TULARE CITY

ADDENDUM # 2 TO BID DOCUMENT
Installation of Painting at various sites
BID OPENING: Wednesday, March 18, 2020 at 11:00 a.m.

Siteplan
 Maple Elementary School
 640 West Cross Avenue - Tulare, CA 93274
 Web Site - www.tcsdk8.org
 Phone (559) 685-7270 FAX (559) 685-7272

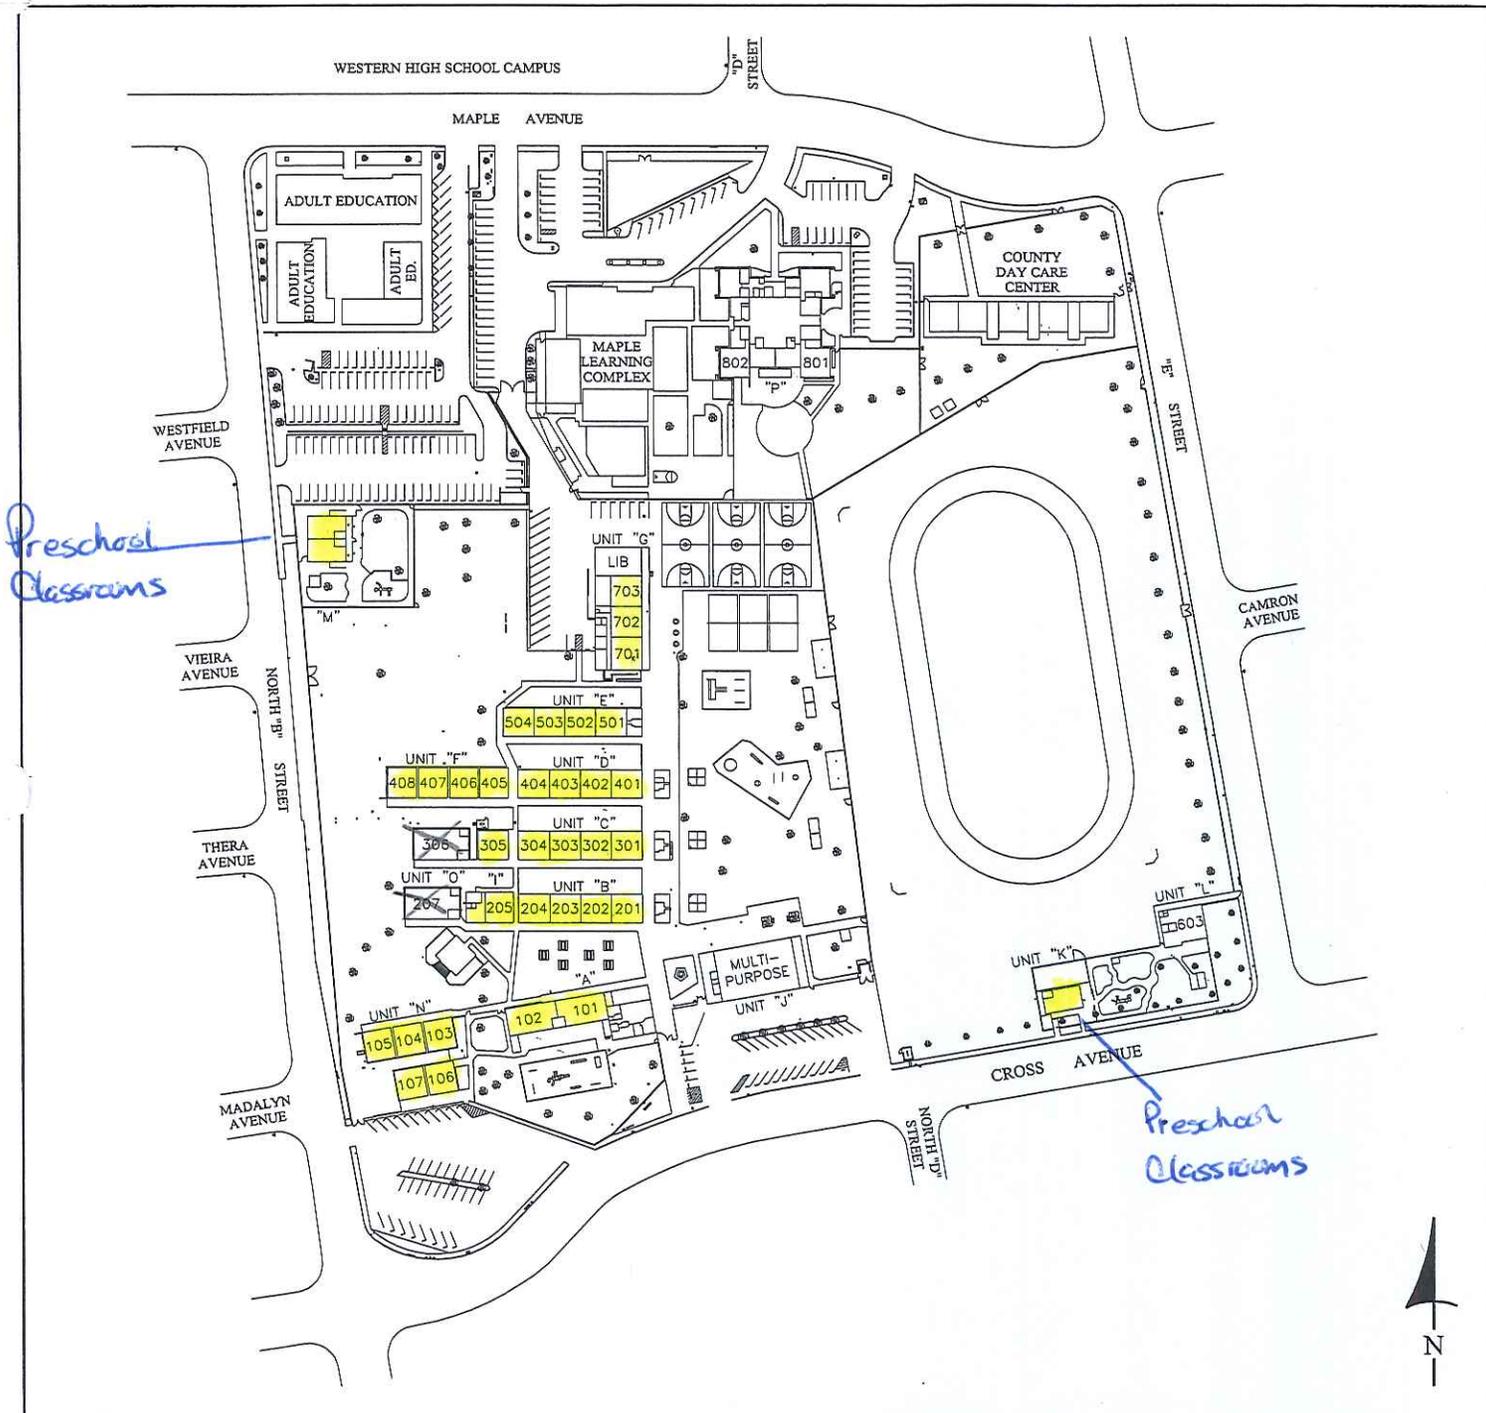
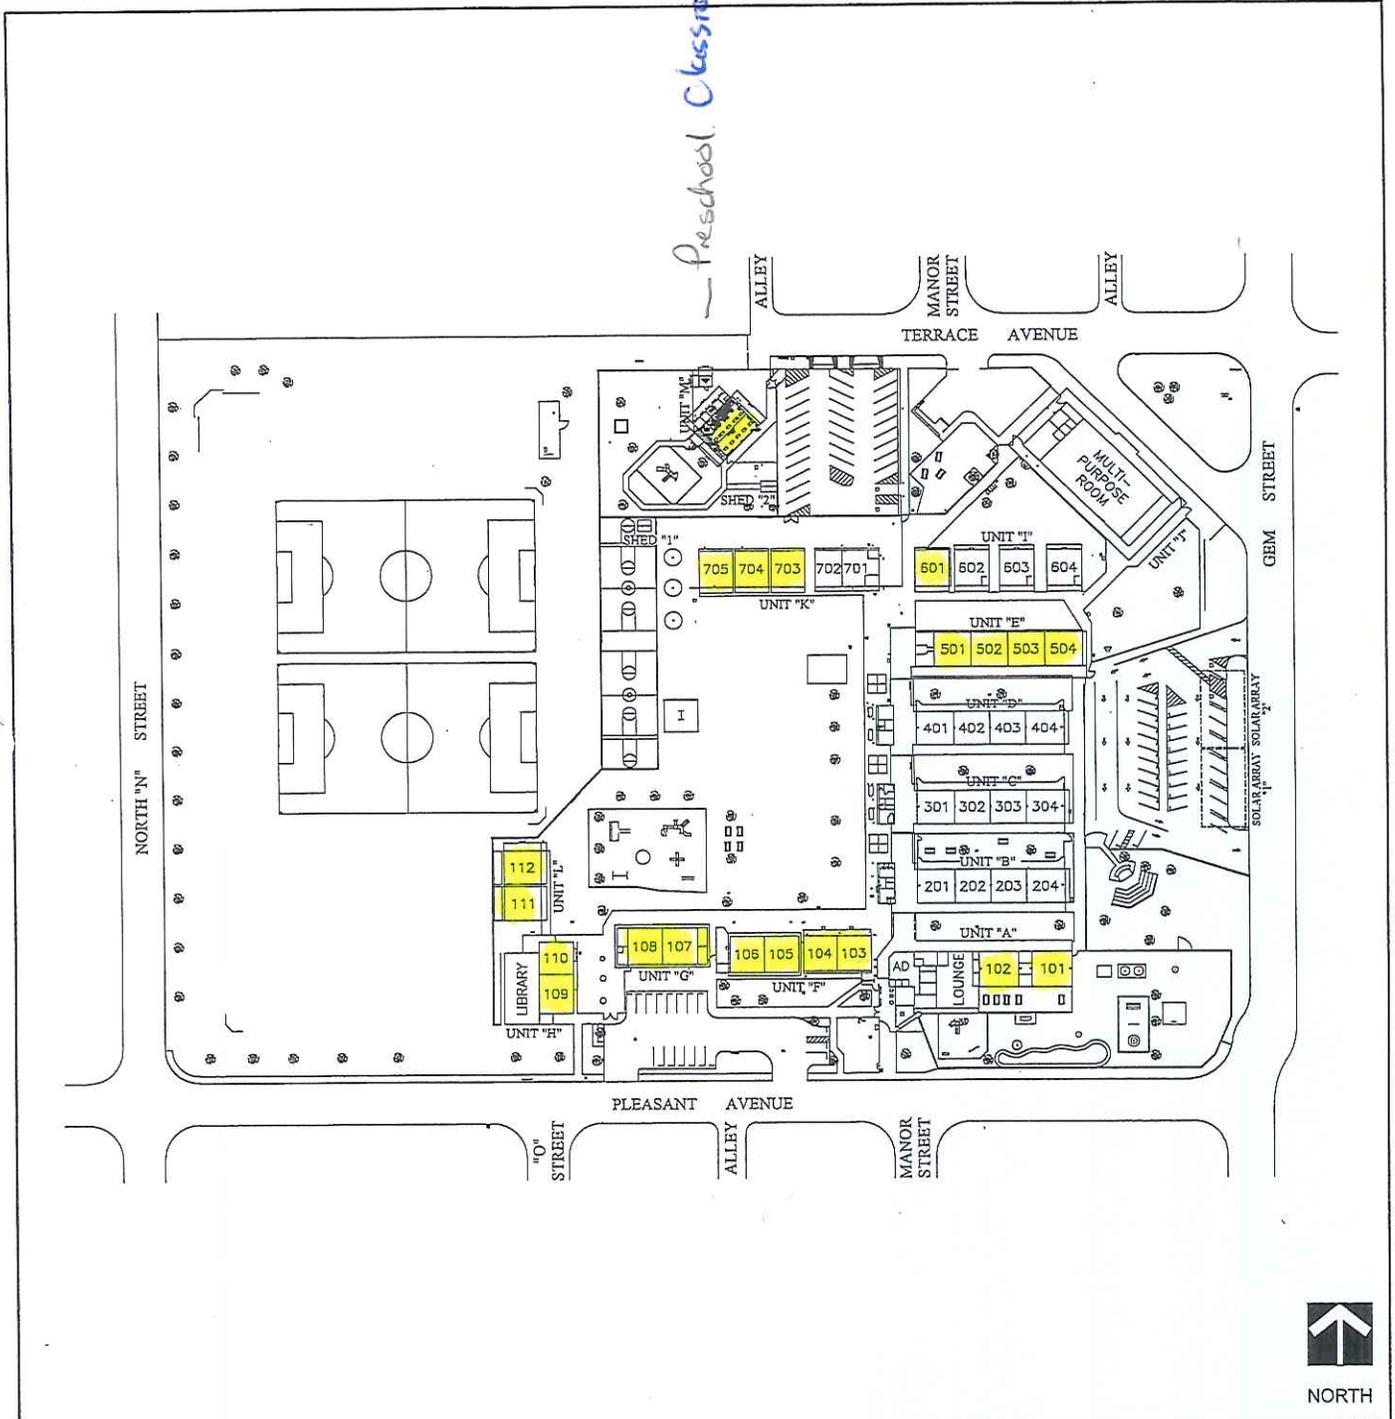
4. Maple School Classrooms to be painted: Rooms 101, 102, 103, 104, 105, 106, 107, 201, 202, 203, 204, 205, 301, 302, 303, 304, 305, 401, 402, 403, 404, 405, 406, 407, 408, 501, 502, 503, 504, 701, 702, 703, & Preschool Classrooms. See drawing attached.

SITE PLAN
LOS TULES MIDDLE SCHOOL
 801 West Gail Avenue - Tulare, CA 93274
 Web Site: www.tcsdk8.org
 Phone: (559) 685-7200, Fax: (559) 685-7248

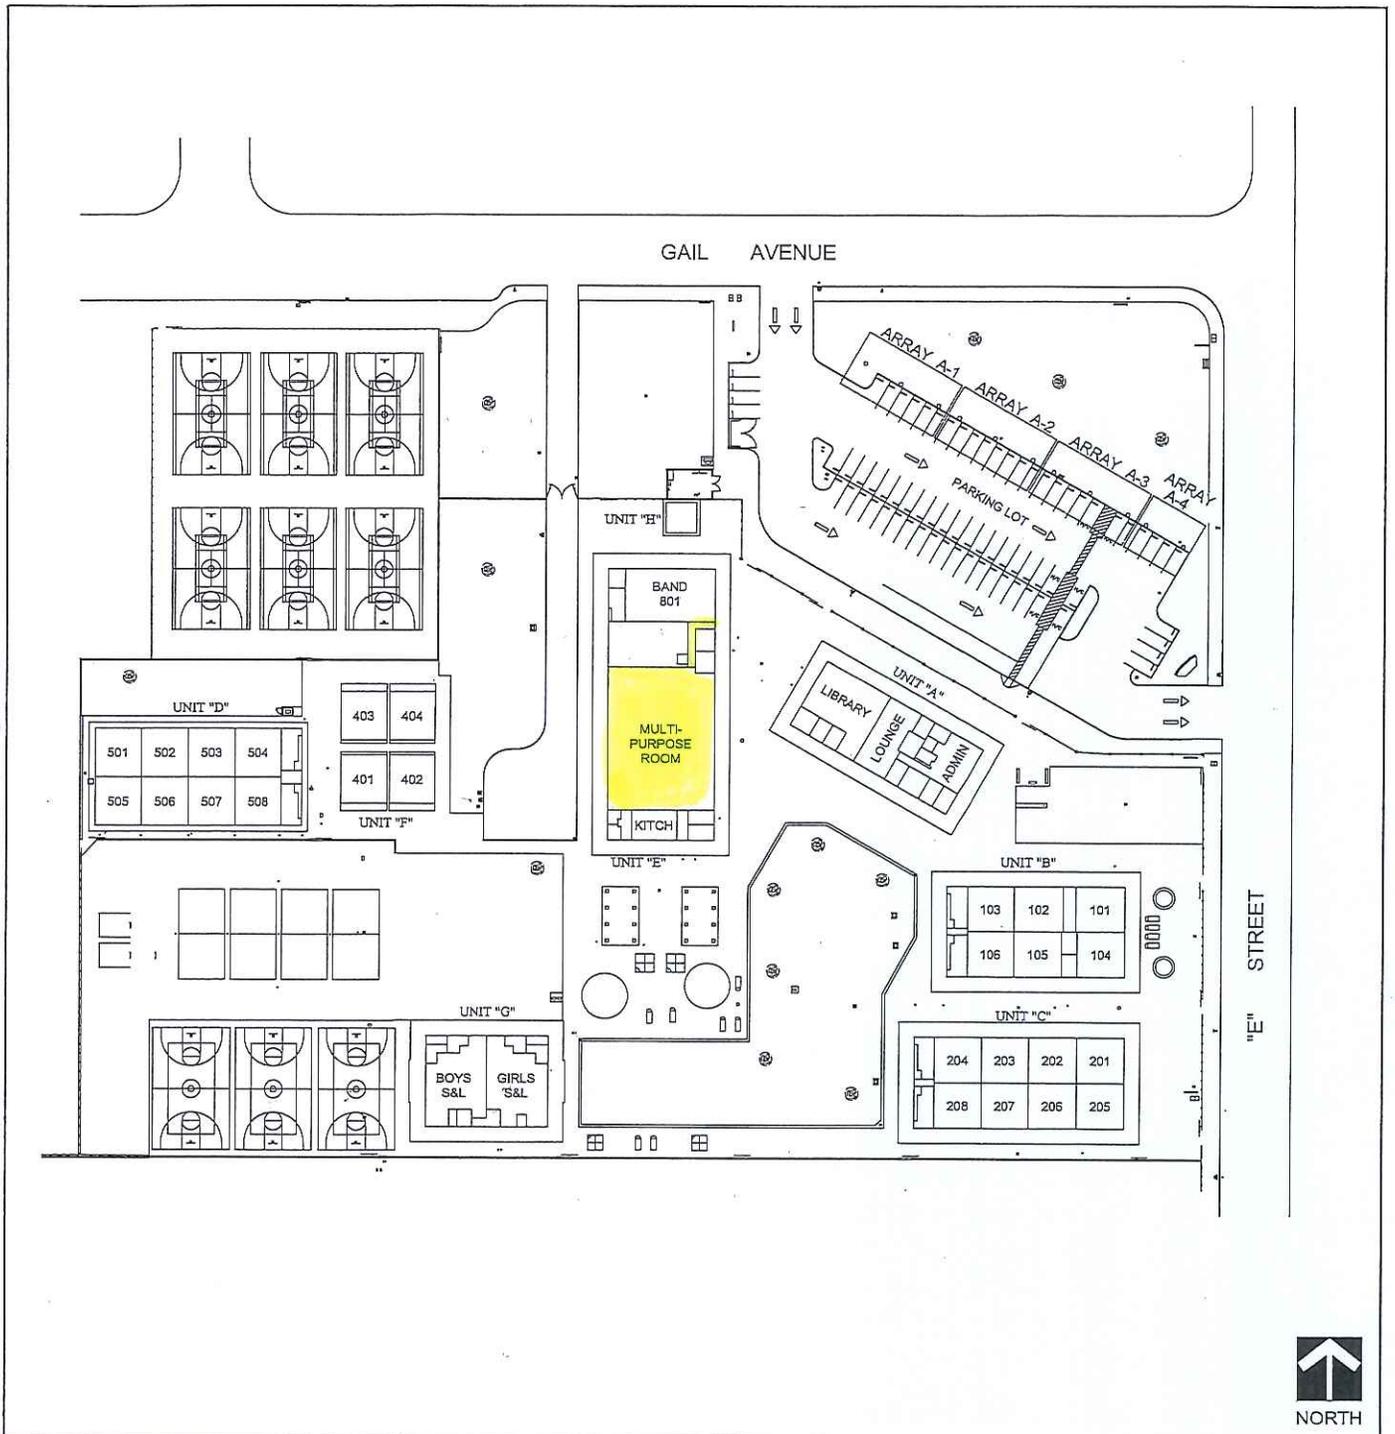
1. In all Classrooms & Multi-Purpose Room Contractor must caulk all joints, corners, & at top of T-bar ceiling. Owner will supply the Caulk.
2. Los Tules Middle School – Multi Purpose room Contractor to paint walls, interior doors, inside of jambs, paint 3 sides of metal doors, & paint 4 side of all wood doors. Multi-Purpose room hallway, Contractor to paint walls and ceiling, interior doors, inside of jambs, paint 3 sides of metal doors & 4 sides of all wood doors. See drawing attached.
